# TURNAGAIN COMMUNITY COUNCIL

TO: Mr. Tom Davis, Senior Planner, Municipality of Anchorage Planning Department  
FROM: Turnagain Community Council  
DATE: Friday, October 26, 2018  
RE: Comments on Proposed Changes to R-2 Zoning and Related Development Standards

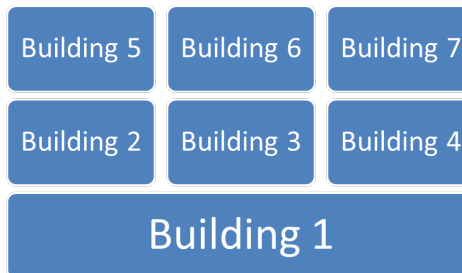
4. The current language indicates that the design standard applies to external-facing facades, i.e. those facing the street and/or adjacent properties. We are concerned about two aspects of this proposal as written in code:
  - a. The design standards for building exteriors should not be exempt simply because the building is far from the property line, or if it is a building surrounded by other similar buildings in a multi-unit development. For example: this hypothetical development has 7 buildings, with Building 3 surrounded by the others in the development.

The language appears to say that while all the other buildings would be required to have an interesting façade, Building 3 in the middle would not. We believe that the development would be more attractive if all buildings are held to the same standards, regardless of location on the property or placement relative to other buildings, so that — regardless of which unit you live in — your view of the other building exteriors has some architectural features.

- b. Even if the intent of this section remains the same, we are concerned that the actual proposed language in the draft is not sufficiently narrow in describing that situation, and instead only refers to buildings located 50 feet or more from the property line:  
Exemptions from this subsection c.: Single-family detached homes are exempt. Building elevations located 50 feet or more from the property line are also exempt.

This would appear to allow any building, regardless of which direction it faces or whether it is part of a multi-unit development that is far enough away from the property line to be exempt from the requirements. If the intent is to only exempt “interior” buildings in a single development, this should be stated more explicitly. For example: if the setbacks in the illustration are 60 feet and 120 feet, respectively, this property would be exempt although it is still the closest/only building to the street.

**Recommendation:** Apply the façade standards for all buildings, and at least three walls, in a multi-unit development, not just those facing the street or other properties. This would ensure that there is more visual interest and better standards than with many current developments.
